Eslite Garments (Bangladesh) Co., Ltd

6 December 2023

2. Observations

Observation 1: Mismatch in as-built drawing. (Factory Building)

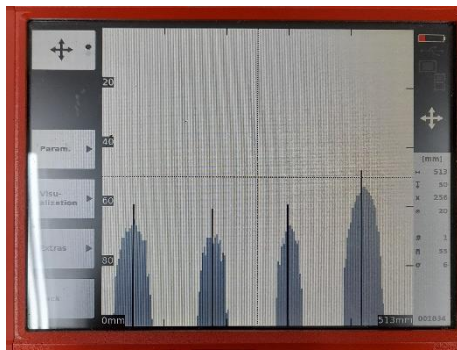
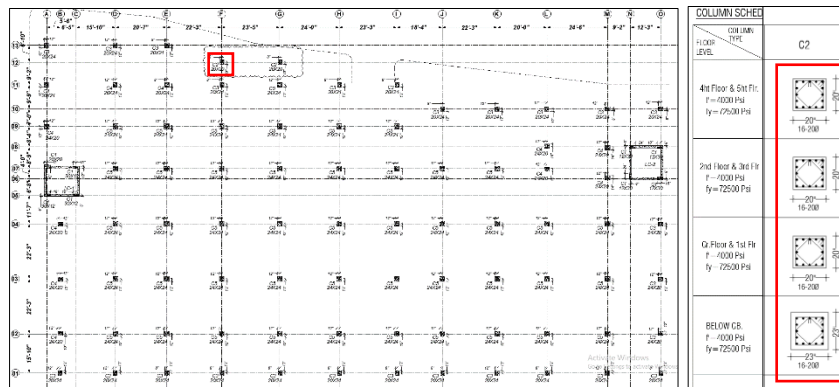
Description: During inspection, the re-bar of the C2 column was found to be less than the as-built drawing. As per the column schedule, the re-bar has been shown 5 numbers on each face. By the ferro-scanning, at the marked location in column layout, 4 number of re-bars were found in one face of C2 column at 5th floor and ground floor.

Observation 2: Load plan does not comply with the BNBC Requirement. (Factory Building)

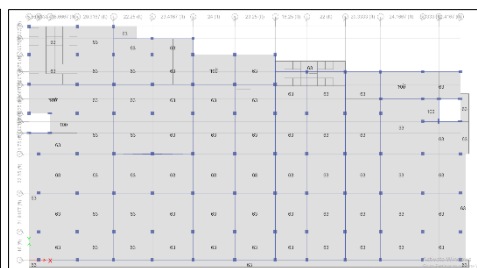
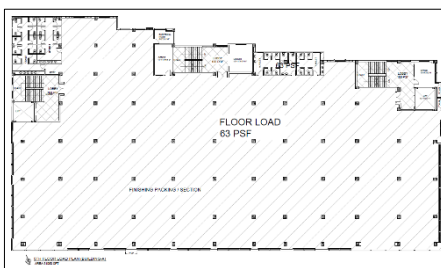
Description: The 5th floor has been proposed for storage. Also, storage loading was also found in some locations of the 5th floor. But load plan has been prepared considering 63 psf instead of 126 psf. At 3rd floor, storage loading was found, but floor loading has been considered 63psf. In FEA model, 63 psf has been assigned in all the floors. Building engineer is required to revise the design documents considering storage loading as per BNBC.

Observation 5: Inconsistencies in design report. (Dormitory Building)

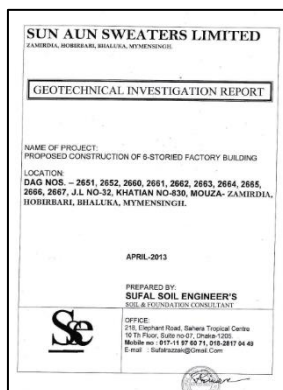
A Design Report was provided for the Dormitory Building at the time of inspection which is prepared based on software analysis. In this report,

- Rebar test report found for 16mm dia rod achieving 370 MPa, 20mm dia rod achieving 555MPa; but 500MPa used for column rebar in design report.
- 3 nos concrete core rest report found for column and 1 no. for beam. In the design report, all core test results are considered for concrete strength calculation for column and beam.
- Foundation adequacy check is not provided for all footing.
- Soil test report from which bearing capacity is considered for foundation calculation in design report, is not for dormitory building as per project name and bore layout.

The building engineer is required to collect minimum 4 nos of concrete core from column and beam-slab individually, revise the design report considering concrete strength for each type of structural member individually, revise rebar strength, produce geotechnical investigation report for this structure and revise foundation adequacy check in the design report based on soil investigation report. Submit the revised design report to the RSC for review.

Observation 09: Inconsistencies in design report. (Utility Building)

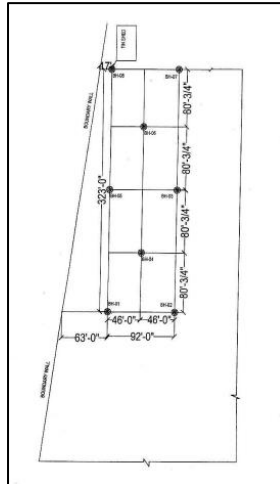
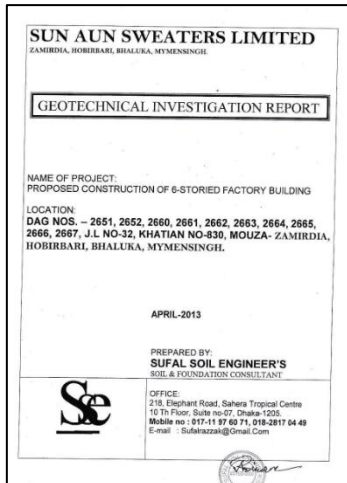
A Design Report was provided for the Utility Building at the time of inspection which is prepared based on software analysis. In this report,

- Foundation adequacy check is not provided for all footing.
- Soil test report from which bearing capacity is considered for foundation calculation in design report, is not for dormitory building as per project name and bore layout.

The building engineer is required to produce geotechnical investigation report for this structure and revise foundation adequacy check in the design report based on soil investigation report. Submit the revised design report to the RSC for review.

Observation 10: Inconsistencies in as-built drawings. (Utility Building)

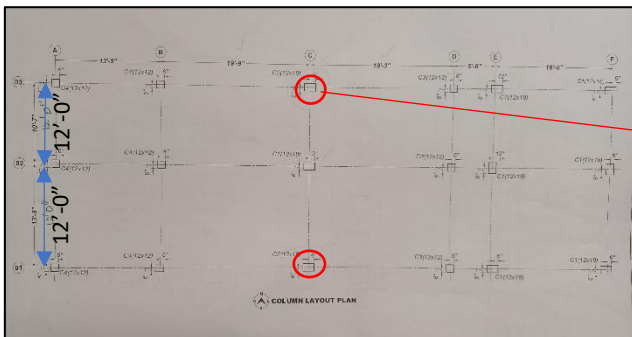
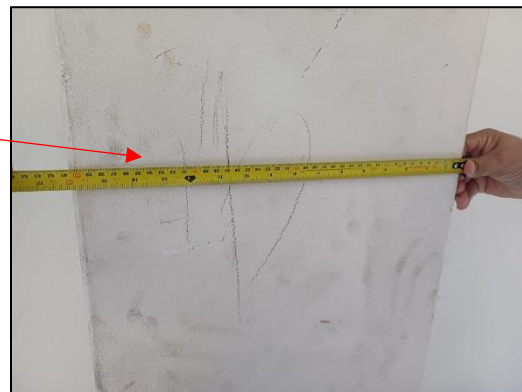
Column size found 12"x15" instead of 12"x18"

Description: In as-built drawing, marked column mentioned 12" x 18", but 12" x 15" found on site. Also grid dimension in north-south direction does not match with as-built drawing. The building engineer is required to survey the whole structure and update the as-built drawing.

Observation 11: Mismatch in provided as-built drawing. (Canteen Shed)

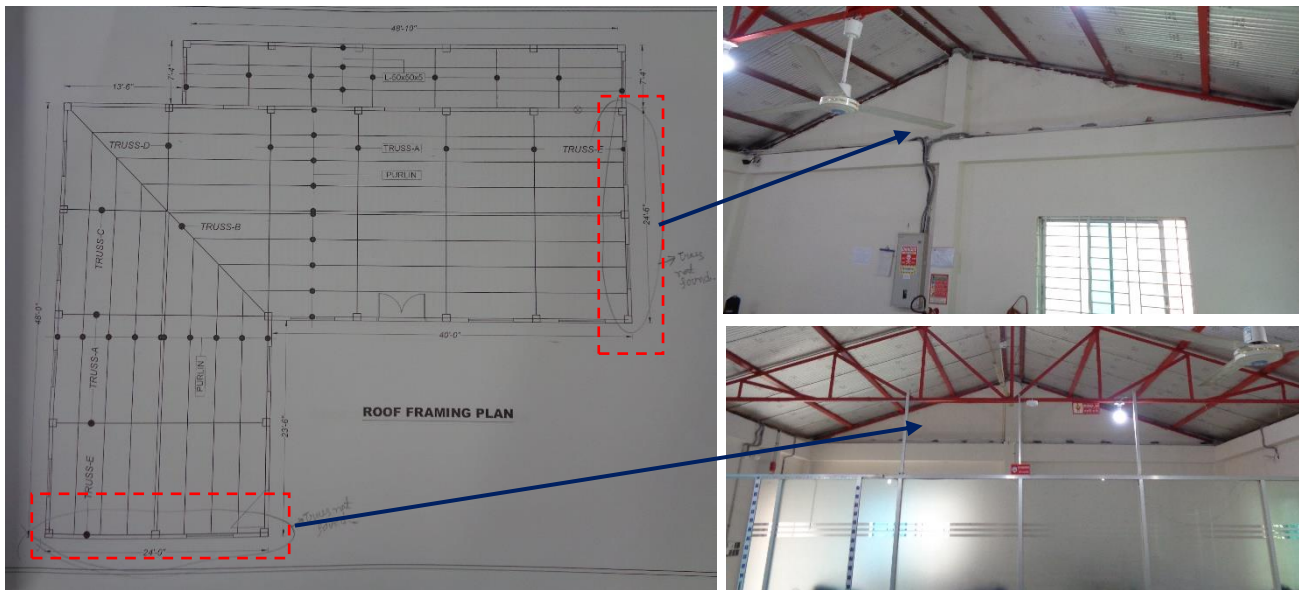
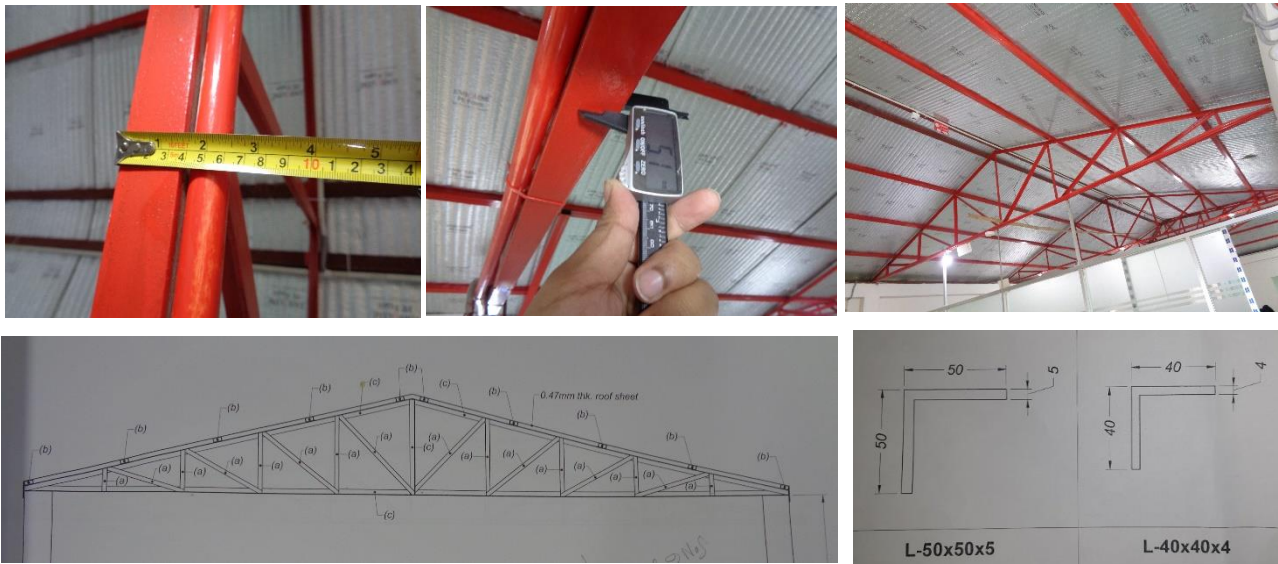
Truss Layout do not match

Size of the truss members and number of vertical members mismatch

Description: Mismatch was found in the as-built drawing and actual site condition. The truss layout does not match with site conditions. In the as-built drawing, truss has been shown at end gable. But the truss was not found at the end gable at site condition. All the Truss members were found 38X38X5mm. But in the provided drawing two sizes of truss members has been shown- L50X50X5mm & L40X40X5mm. Also, the size of the truss members shown in drawing does not indicate any members. The total number of the vertical members do not match between site condition and drawing. Building engineers is required to survey the whole structure and update the as-built drawing. Revise the design documents based on actual site condition.
